工程指示編號：EI / 9100 / 25 修改版次：

工程名稱：將軍澳日出康城

工程項目：幕牆 第9次 補玻璃 19 件 (小業主單)

項目: 鋁窗, 鋁門及幕牆玻璃的驗收表格

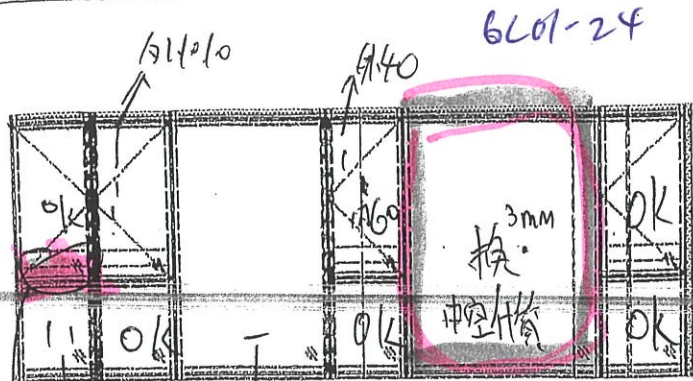
起門漏風, 抽色風內外.  
廚房窗抽色.  
幕抽色 白灰.

項目: 鋁窗, 鋁門及幕牆玻璃的驗收表格

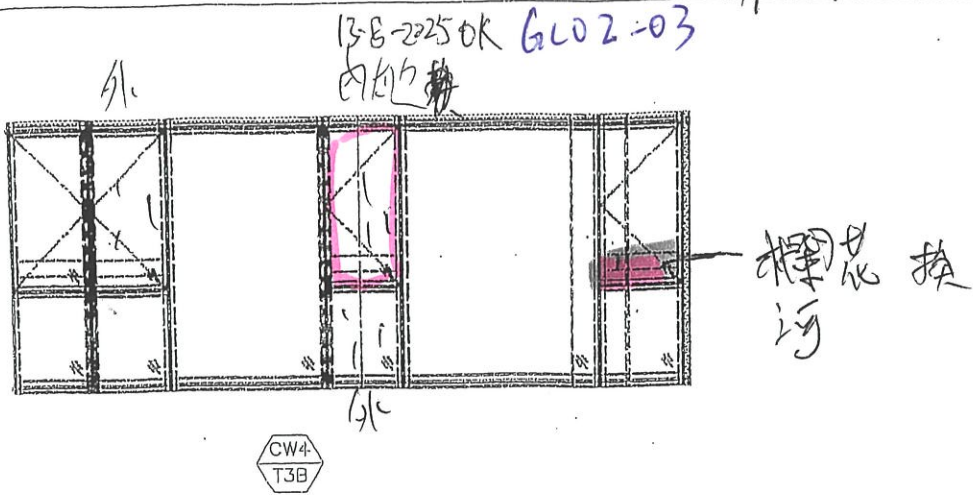
室內已磨

13-8-2025 室內已磨

GL01-23

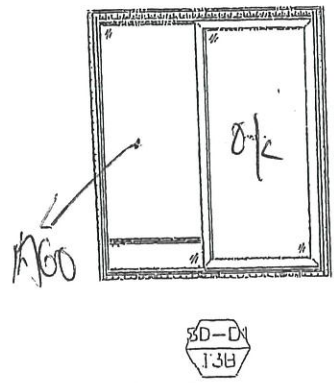
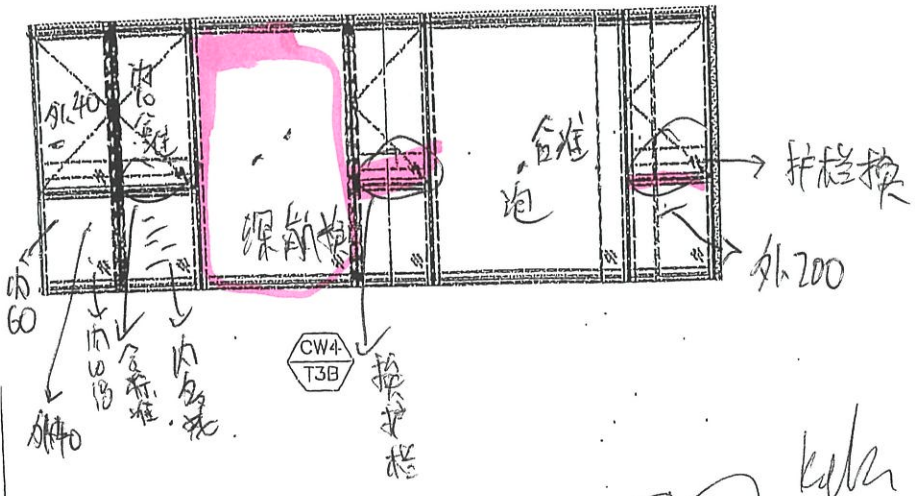
拉手緊, 漏風, 批色.

幕牆拉手不順, 膠條太長, 補膠

批色.

剛所窗不順.

項目: 鋁窗, 鋁門及幕牆玻璃的驗收表格 01

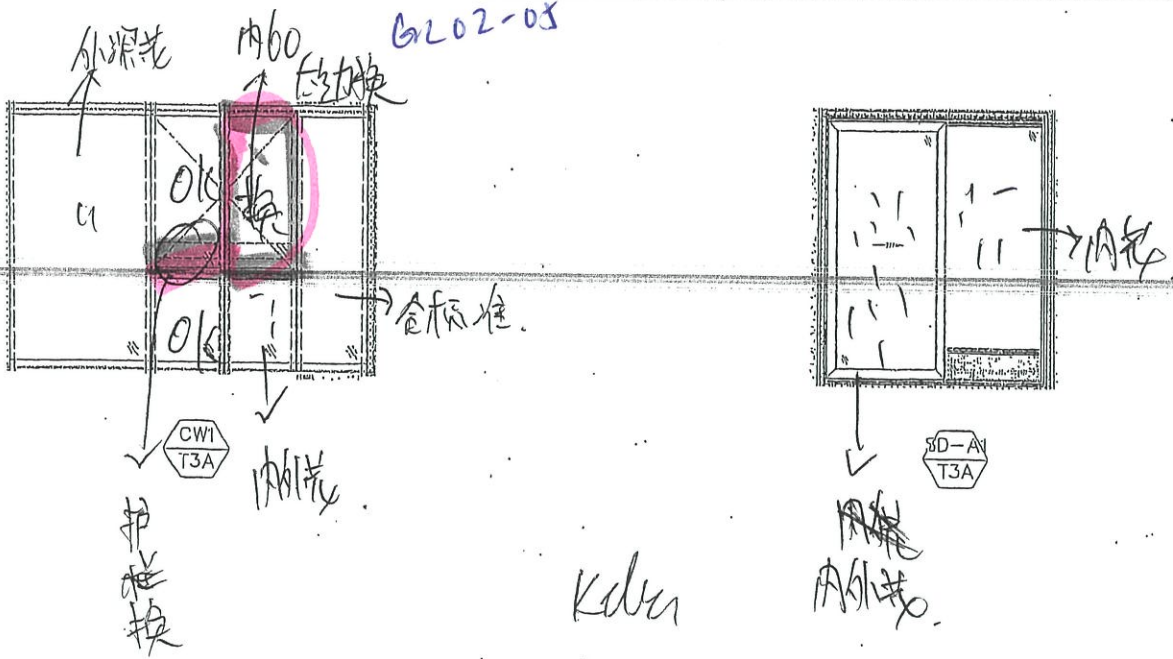
趟門執色, 幕牆門外清膠紙, 執膠

幕牆執色

項目: 鋁窗, 鋁門及幕牆玻璃的驗收表格

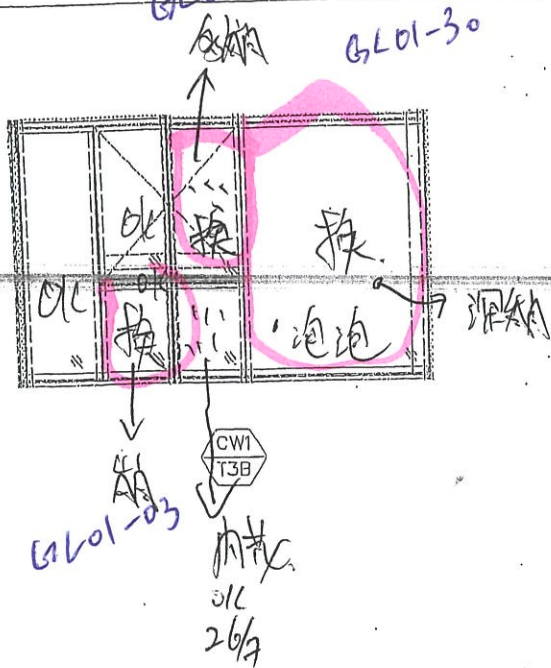
趙山拉手不順, 執色,

幕牆執色, 和收口.

6201-14

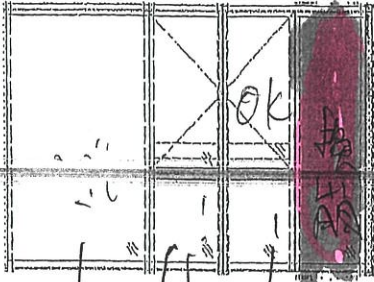
內始裝  
沙眼  
外

窗難鎖

項目: 鋁窗, 鋁門及幕牆玻璃的驗收表格

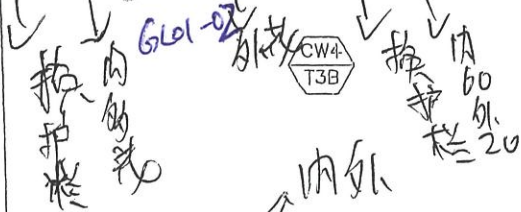
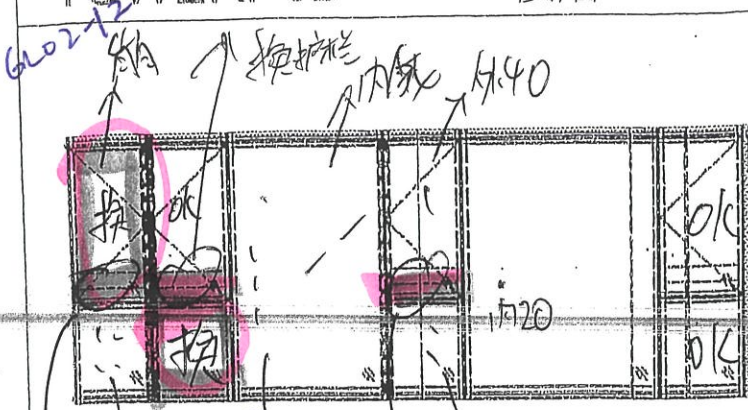
趟門漏風  
幕牆漏風 呔膠,  
執色  
廁所窗漏風, 副房窗執色

GL01-36F6

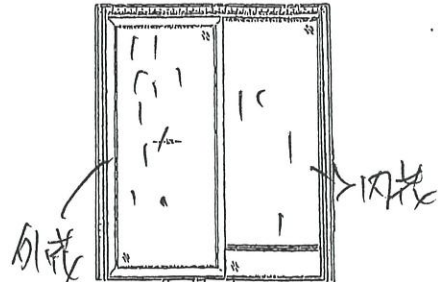
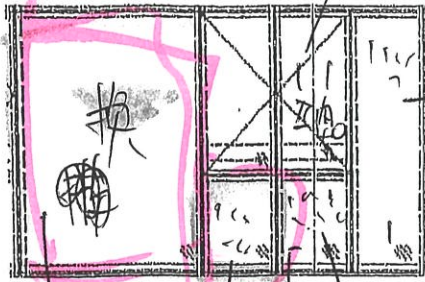
物料由外內 裝不順拆膠
